UPPER UWCHLAN TOWNSHIP
PLANNING COMMISSION
AGENDA

January 11, 2024

Reference: Wertz Farm
 Minor Subdivision Plan – Final Submittal
 Upper Uwchlan Township, Chester County, PA

**Wertz Farm (aka Robert Smith Farm) Final/Minor Subdivision Plan: Impact
on Historic Robert Smith Farm Buildings — with Revised Final Approved
Recommendations**

JOB NUMBER: 1302TD019-2
 DRAWN BY: BJK
 CHECKED BY: SJH
 SCALE: 1"-100'
 DATE: 10/20/23
 DRAWING NUMBER:
 SHEET: C200

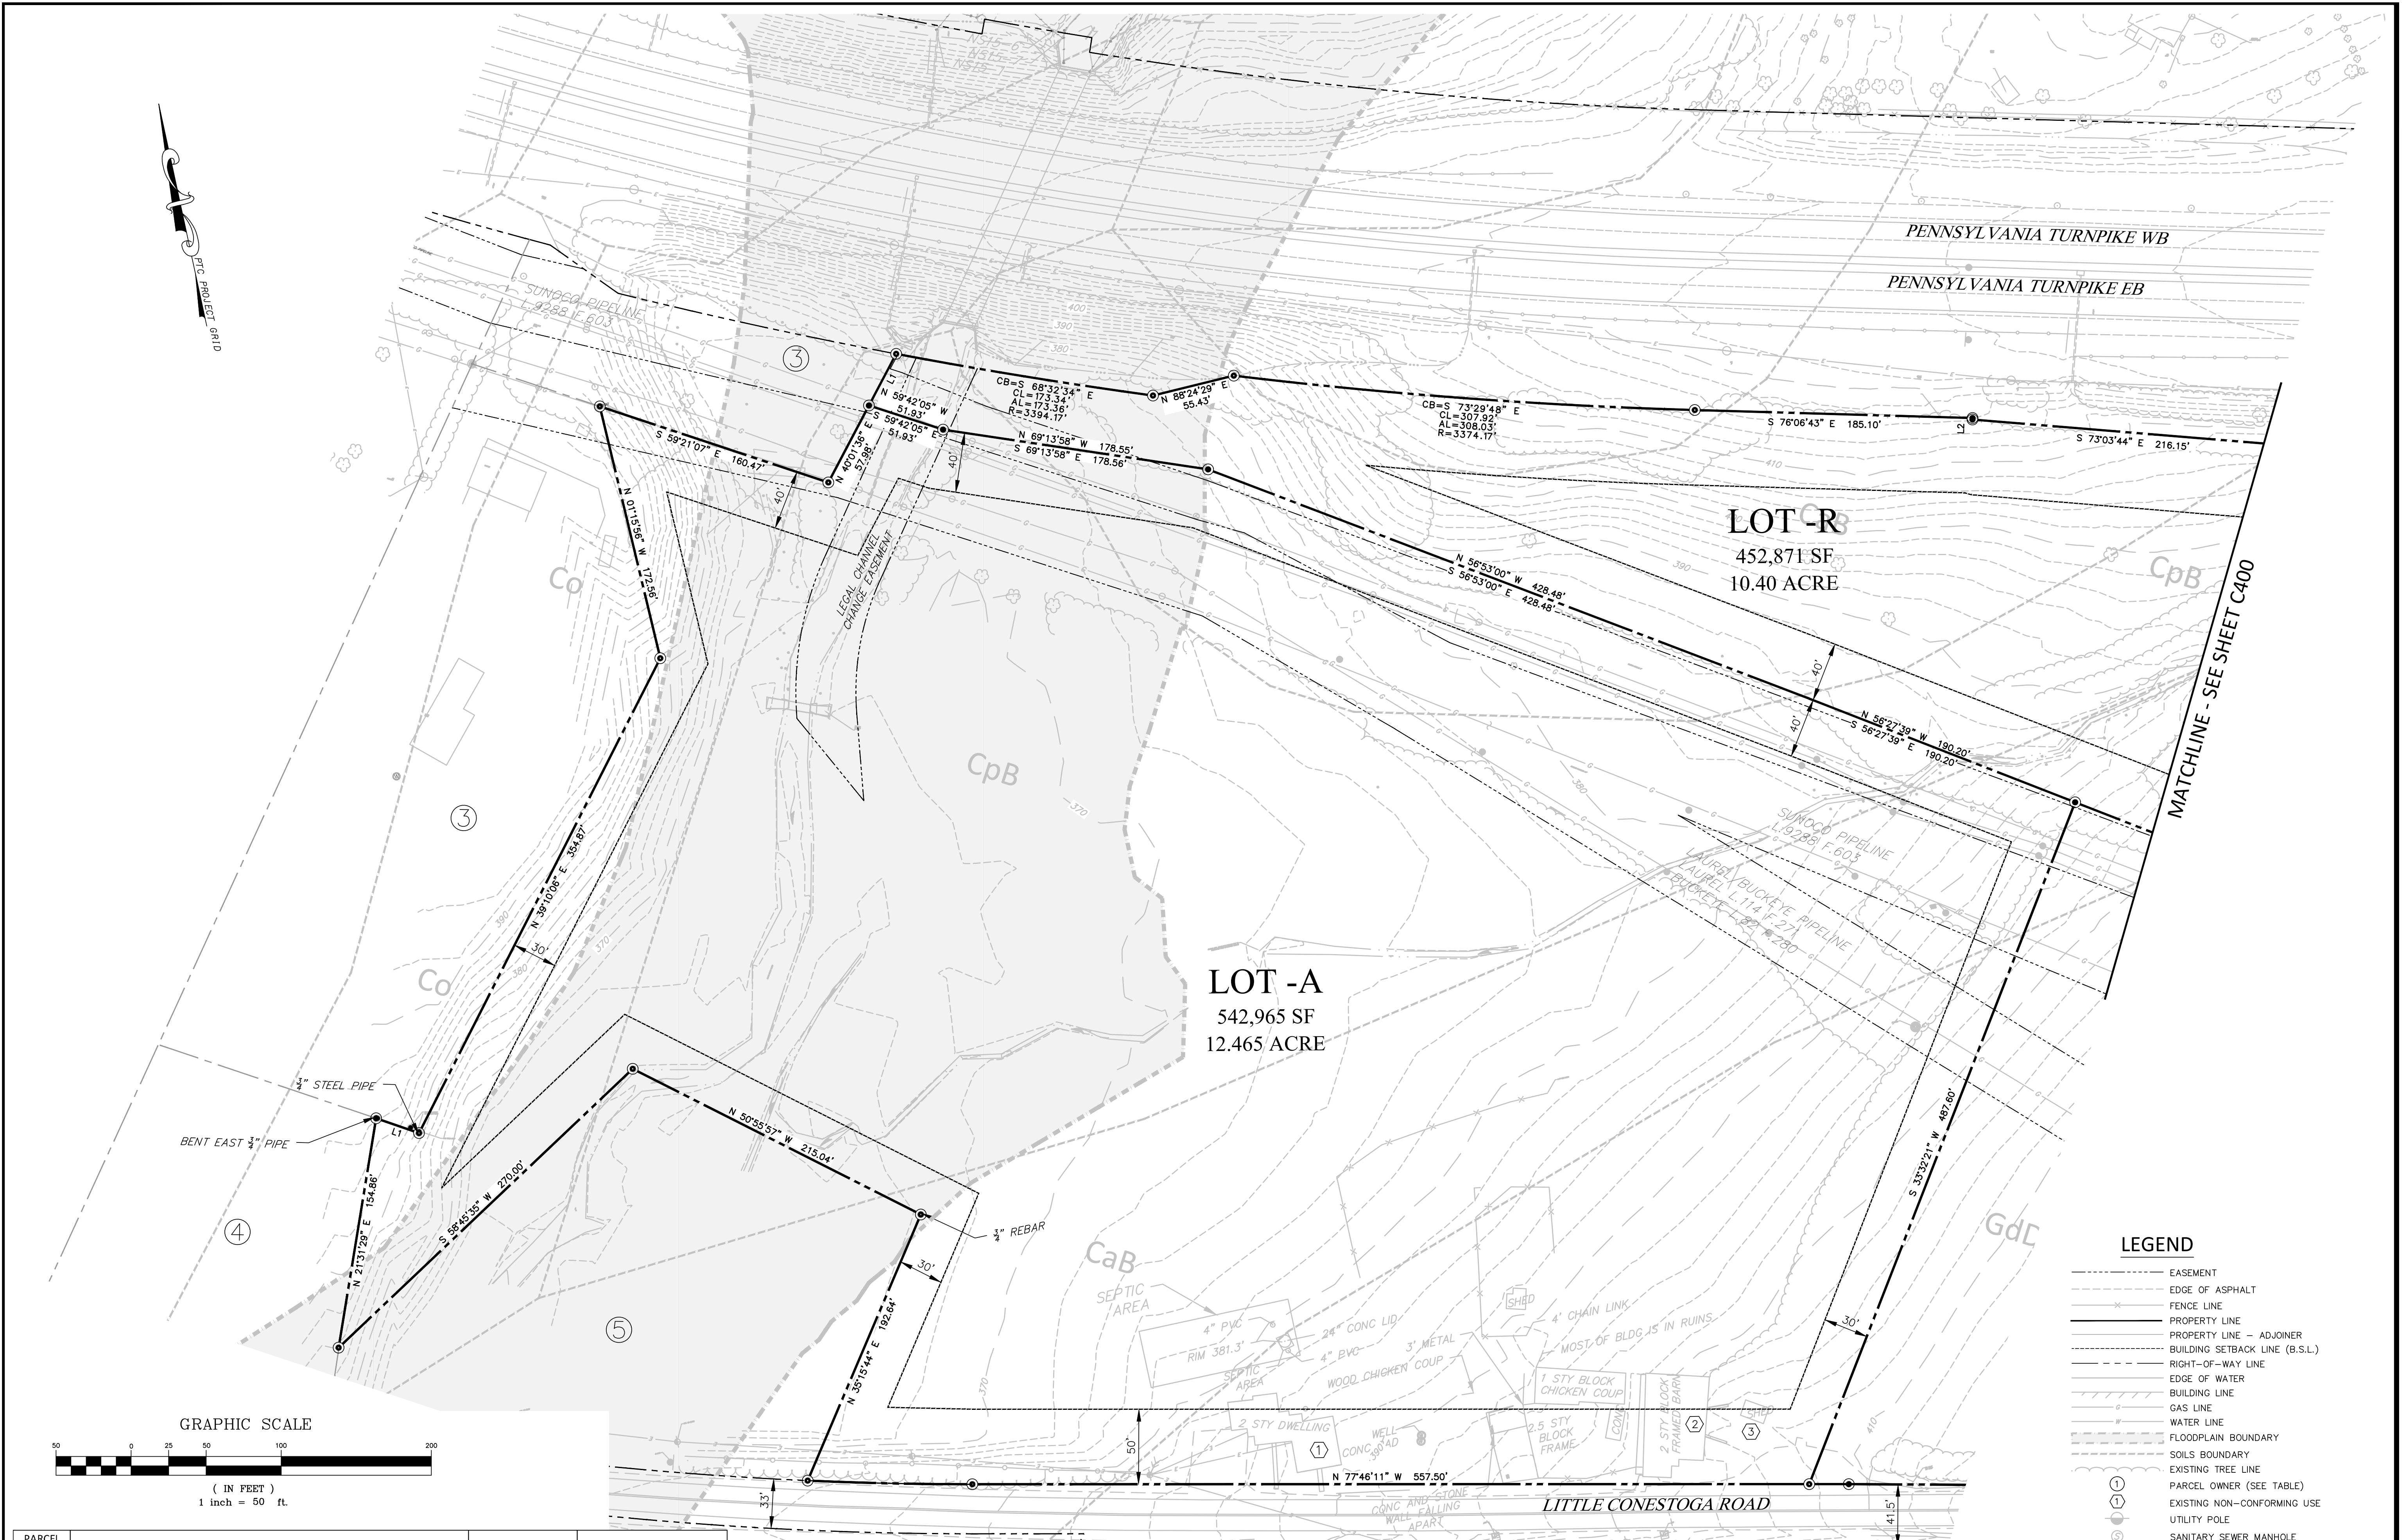
1. Revise General and Plan Notes #7 on Sheet C100 to include Lot R.
2. A building setback line for the current property should be provided on sheet C200. In addition, the proposed building setback line for proposed Lot R which is shown on sheet C200 should be removed.
3. Revise General and Plan Notes #2 as it is unclear and potentially incorrect.
4. The Zoning Information table indicates public water supply and sanitary sewer disposal; however, the existing dwelling appears to be served by a well and on-site septic. Please verify the water and sewer.
5. Revise all years (i.e., 2022 and 2023) included in signature blocks on Sheet 1 to 2024.
6. Revise the plan sheet titles to match those listed in the Drawing Index on Sheet 1 and remove “& Land Development” from all title blocks.
7. Label Milford Road on Sheet 4.
8. Please cite the source of the Floodplain Boundary as well as the Zone.

JOB NUMBER: 1302TD019
 DRAWN BY: BJK
 CHECKED BY: SJH
 SCALE: 1"=50'
 DATE: 10/20/23
 DRAWING NUMBER:
 SHEET: C300

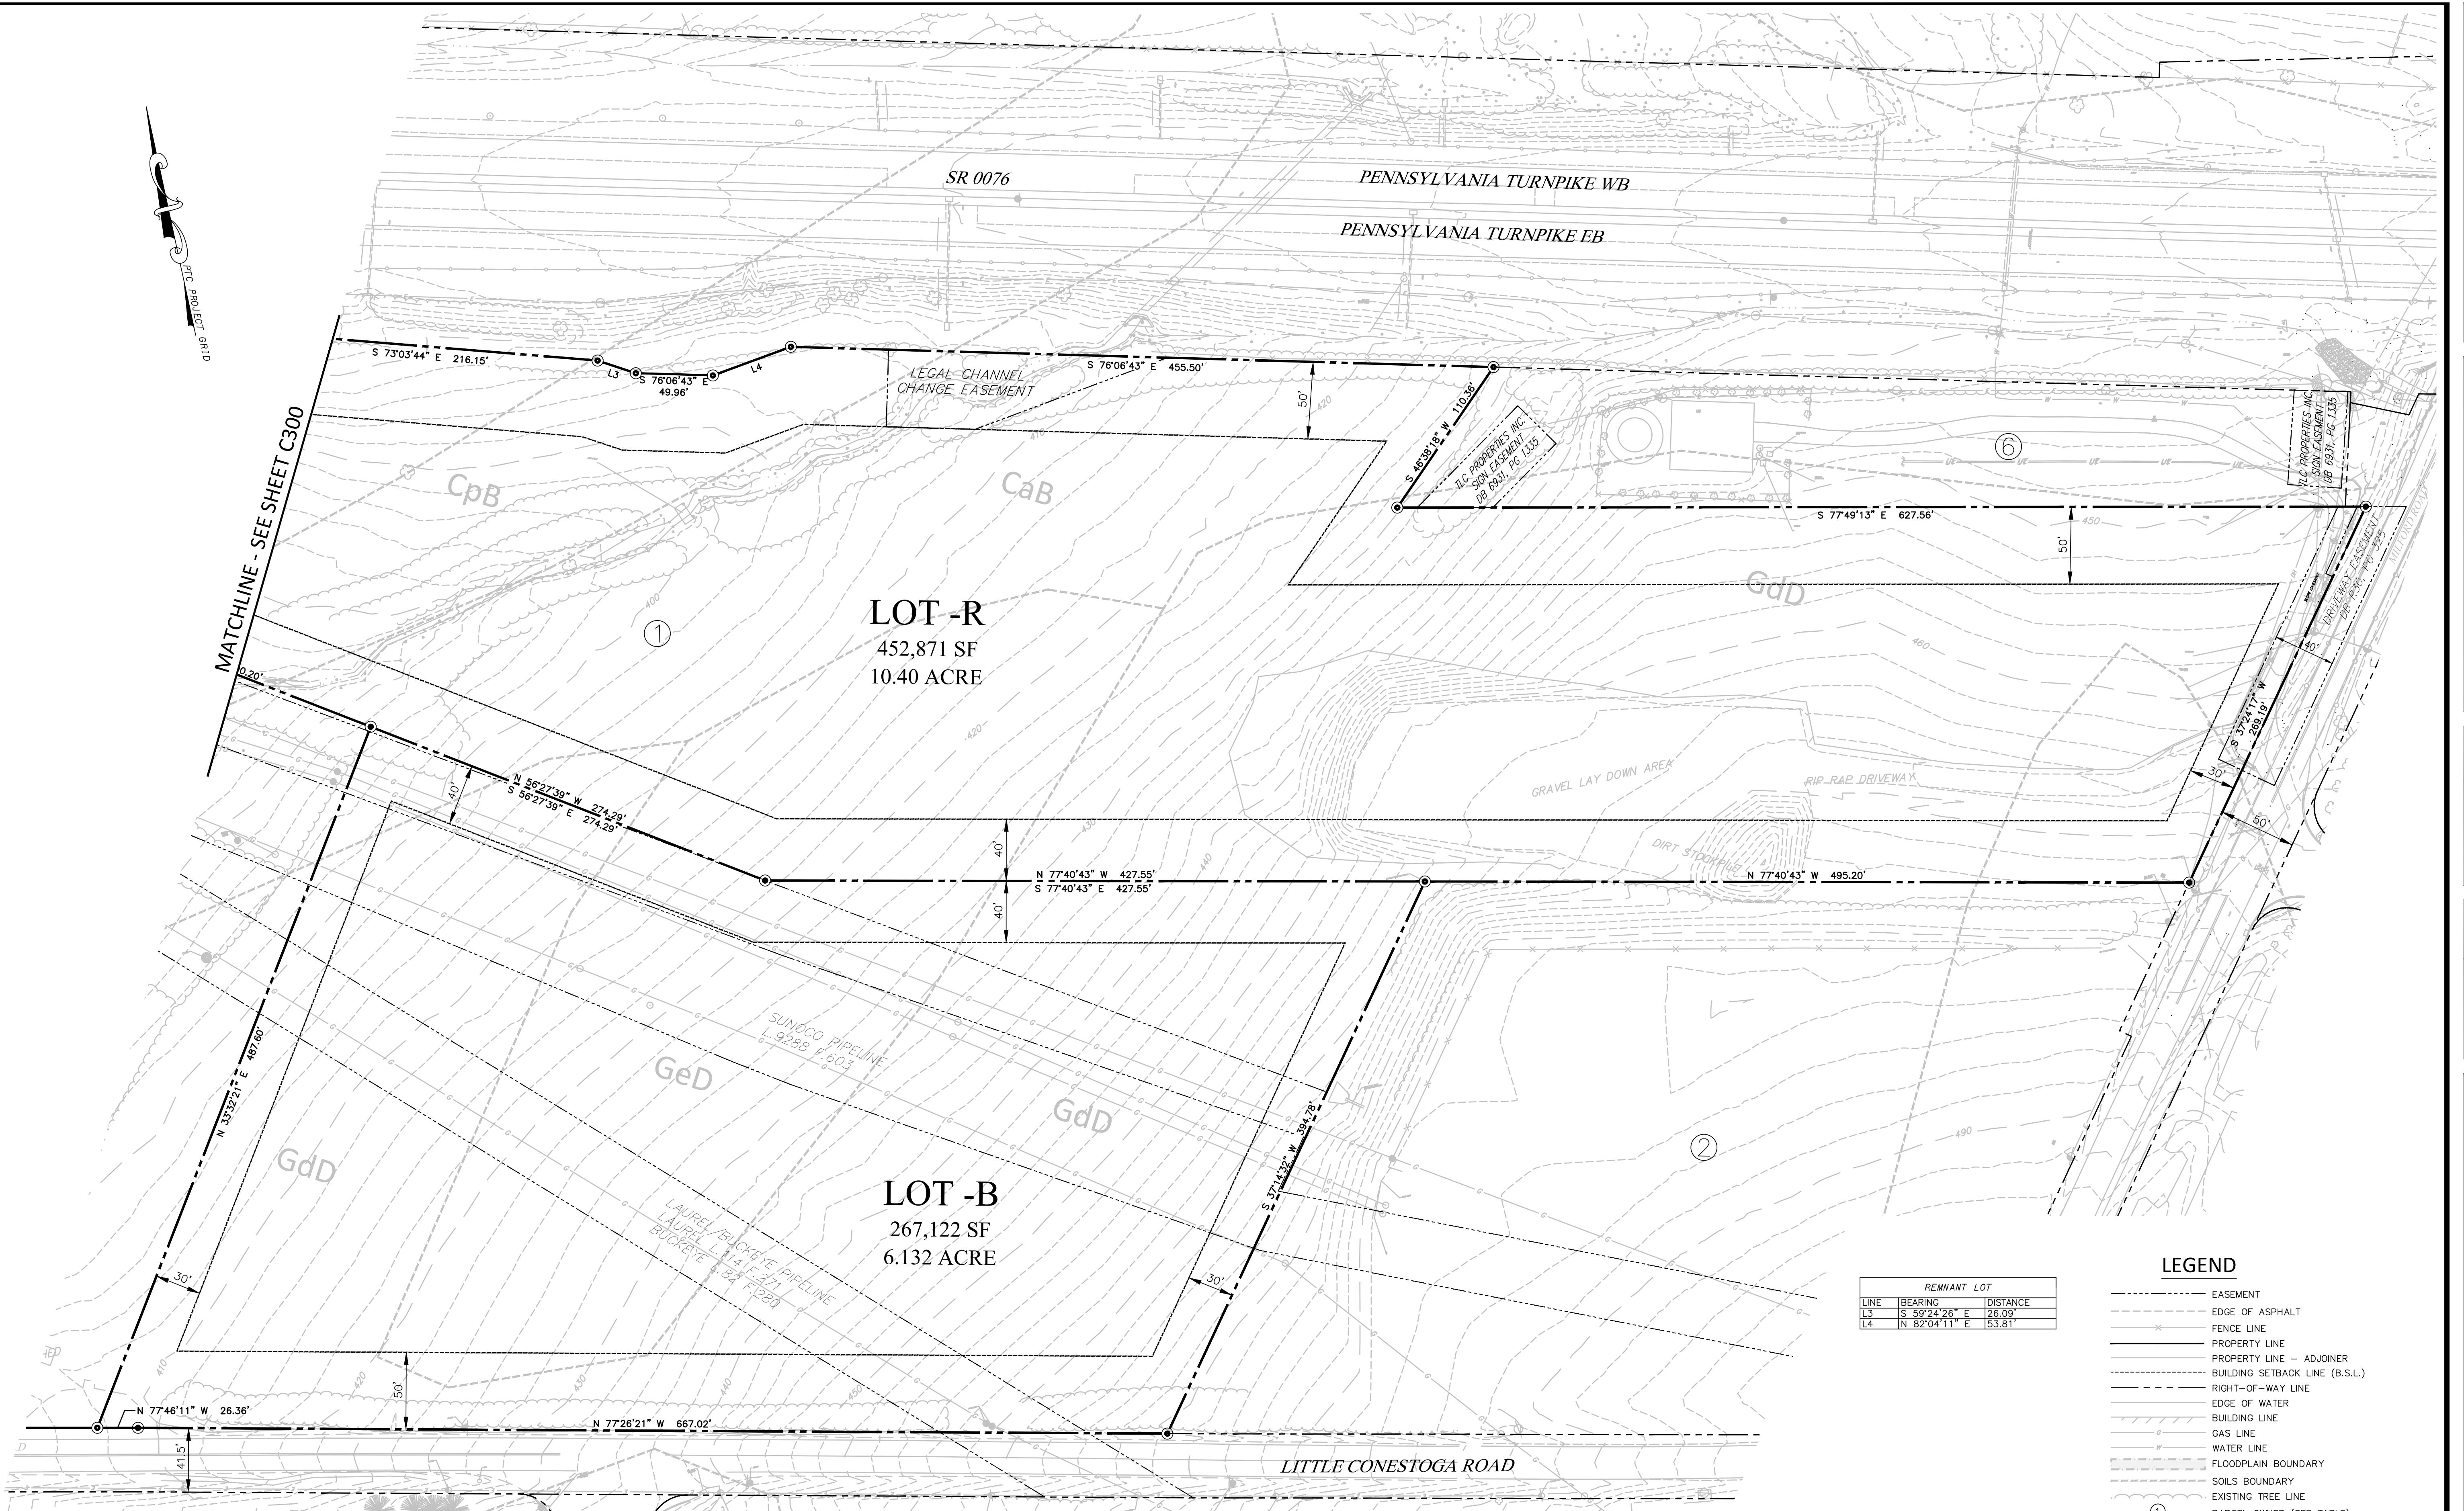
4. Section 200-18.C(1) – Revise the Front yard setback for proposed Lot R along Milford Road shown on Sheet C400 plan view as it is incorrect. Label the FY setback for Lot R along the Turnpike on Sheet C300. We note that the FY setbacks from Little Conestoga Road should be from the ultimate right-of-way which does not appear to be shown correctly.
